# IEEE P802.18 Radio Regulatory Technical Advisory Group (RR-TAG)

Proposed Response to China MIIT Consultation on "Ultra-Wideband (UWB) Equipment Radio Management Regulations"							
Date: 2023-01-28							
Author(s):							
Name	Company	Address	Phone	email			
Dries Neirynck	Ultra Radio Ltd						
Ben Rolfe	Blind Creek Associates						
Riku Pirhonen	NXP Semiconductors			riku.pirhonen@nxp.com			
Billy Verso	Qorvo

Re: Consultation on the "900MHz Frequency Band Radio Frequency Identification (RFID) Equipment Radio Management Regulations (Draft for Comments)" and "Ultra Wideband (UWB) Equipment Radio Management Regulations (Draft for Comments)"

# Figure 1: Comparison of the power spectrum density mask between the proposed regulation of China MIIT (i.e., "Proposed mask") and the requirements defined in IEEE Std 802.15.4-2020 [1] for IEEE HRP UWB PHY channels 8 and 10 (i.e., "ch8" and "ch10").

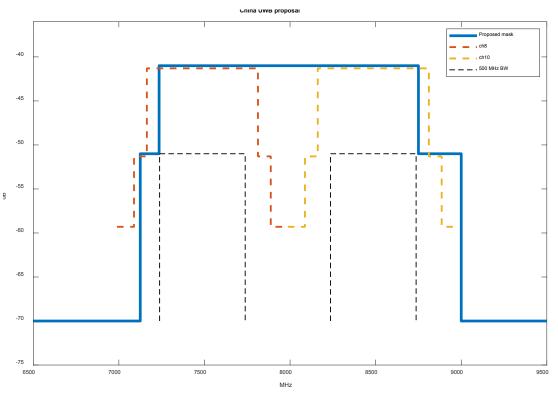
Figure 1 shows the power spectral density masks between the proposed regulation and those defined in [1] for IEEE HRP UWB PHY channels 8 and 10. Note that Channel 9 is left out intentionally to improve the clarity of the figure.

Figure 1 illustrates two issues with the proposed power spectrum density mask with respect to use of devices implementing IEEE Std 802.15.4-2020. First, the power spectrum density mask defined in IEEE Std 802.15.4-2020 does not fit inside the proposed limits. Secondly, the -10 dB minimum bandwidth is defined to be 500 MHz without any extra spectrum to account for the roll-off. The figure shows that meeting the minimum bandwidth requirement (staying above the dotted black line of "500 MHz BW") and, at the same time, staying within the proposed emission limits (under blue line of "Proposed mask") using the UWB channels defined by [1], is impossible with a practical implementation.

Given the center frequency of the IEEE HRP UWB PHY channel 5 is equal to 6489.6 MHz, the European rules define a frequency separation of 489.6 MHz from the center frequency to the band edge with -70 dBm/MHz limit. To enable use of IEEE HRP UWB PHY channel 8 with the center frequency of 7488 MHz in China, the corresponding separation for channel 8 would require the lower -70 dBm/MHz band edge not to be higher than 6998 MHz. It is worth noticing that the -51 dBm/MHz limit does not exist in [6]. If a -51 dBm/MHz limit is considered necessary, IEEE 802 LMSC suggests MIIT to consider the spectrum mask defined in the IEEE Std 802.15.4-2020 and set the -51 dBm/MHz limit at 7163 MHz or below.

Similar expansion of the available band would be needed for the upper UWB band limit to enable IEEE HRP UWB PHY channel 10 with the center frequency of 8486.4 MHz, where a -70 dBm/MHz limit would be set to 8976 MHz or above, and the possible -51 dB/MHz limit at or above 8810 MHz.

Frequency range	EIRP limit	
Below 6998 MHz	-70 dBm/MHz	
6998 MHz – 7163 MHz	-51 dBm/MHz	
7163 MHz – 8810 MHz	-41 dBm/MHz	
8810 MHz – 8976 MHz	-51 dBm/MHz	
Above 8976 MHz	-70 dBm/MHz

Figure 2: Power spectrum density of the IEEE HRP UWB PHY channel 5 with center frequency of 6489.6 MHz (i.e., "ch5") and the European band edge limits at 6 GHz (i.e., "Europe")

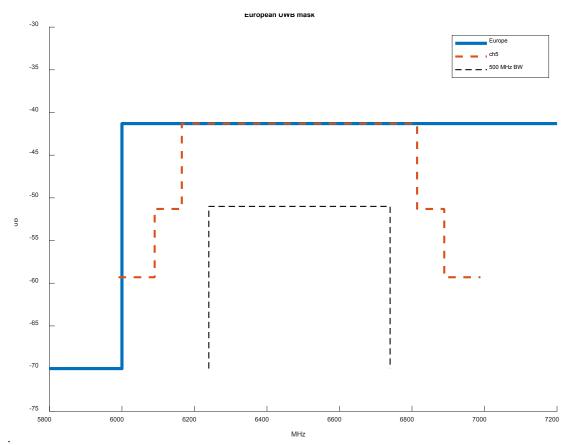
For comparison, Figure 2 shows the power spectral density mask of channel 5 and the existing European regulatory emission limits [4] at the band edge. This could be used as a reference for possible limits. The European limit at 6 GHz is not very relaxed by any means, but it does allow a feasible implementation. The 500 MHz minimum bandwidth limit is presented in the figure for reference, but it is not a requirement in Europe.
